# Access Compliance Report

## Public Rights-of-Way

Intersection ID: 6062	Main Street: BALANCING_ROCK_CT	Cross Street: SAGESTONE_CT	Location:	E
ADA ID: E445AC0782C3	Ramp Type: Perp	Initial Pass/Fail: Fail	Overall Compliance: No	Severity Score: 25
Codes/Mitigation Info/Possible Solution		Field Measurements/Component Compliance

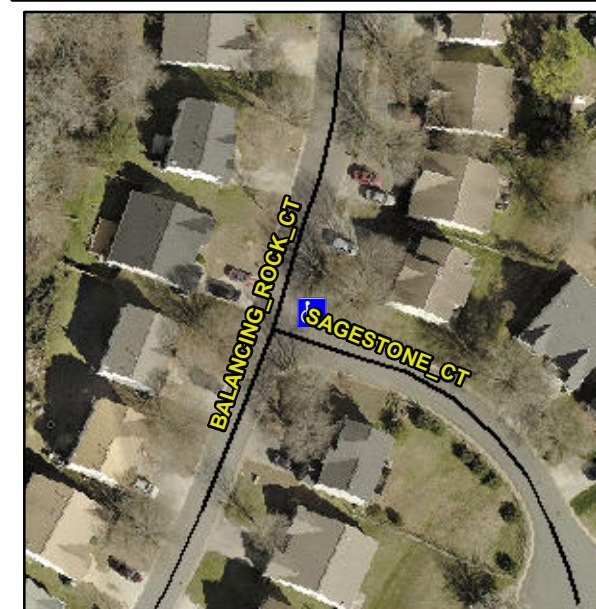
**Not Found, R304.5.3**

Compliance	Description	Data	Compliance	Description	Data
N/A	Ramp Length (in)	52.0	Yes	Ramp Slope (%)	5.8
Yes	Ramp Width (in)	48.0	No	Ramp XSlope (%)	12.3
N/A	Flare Type LT	N/A	N/A	Flare Type RT	N/A
N/A	Flare Slope LT (%)	N/A	N/A	Flare Slope RT (%)	N/A
N/A	Flare Traversable LT?	N/A	N/A	Flare Traversable RT?	N/A
N/A	Landing Length (in)	N/A	N/A	DWS Provided?	N/A
N/A	Landing Width (in)	N/A	N/A	DWS Contrast?	N/A
N/A	Landing Slope (%)	N/A	N/A	DWS Length (in)	N/A
N/A	Landing X Slope (%)	N/A	N/A	DWS Full Width?	N/A
N/A	Landing Curb? (Y/N)	N/A	N/A	DWS Offset (in)	N/A
N/A	Shared Landing?	N/A			
N/A	Gutter Ponding?	N/A	N/A	Gutter Slope (%)	N/A
N/A	Gutter Lip Ht (in)	1.0	N/A	Gutter X Slope (%)	N/A
N/A	Painted X Walk1?	No	N/A	Painted X Walk2?	N/A
	X Walk 1 Direction	To S		X Walk 2 Direction	N/A
N/A	X Walk 1 Width (in)	N/A	N/A	X Walk 2 Width (in)	N/A
	X Walk 1 Slope (%)	15.1		X Walk 2 Slope (%)	N/A
	X Walk 1 X Slope (%)	7.7		X Walk 2 X Slope (%)	N/A

**Remove & Replace Entire Ramp.**
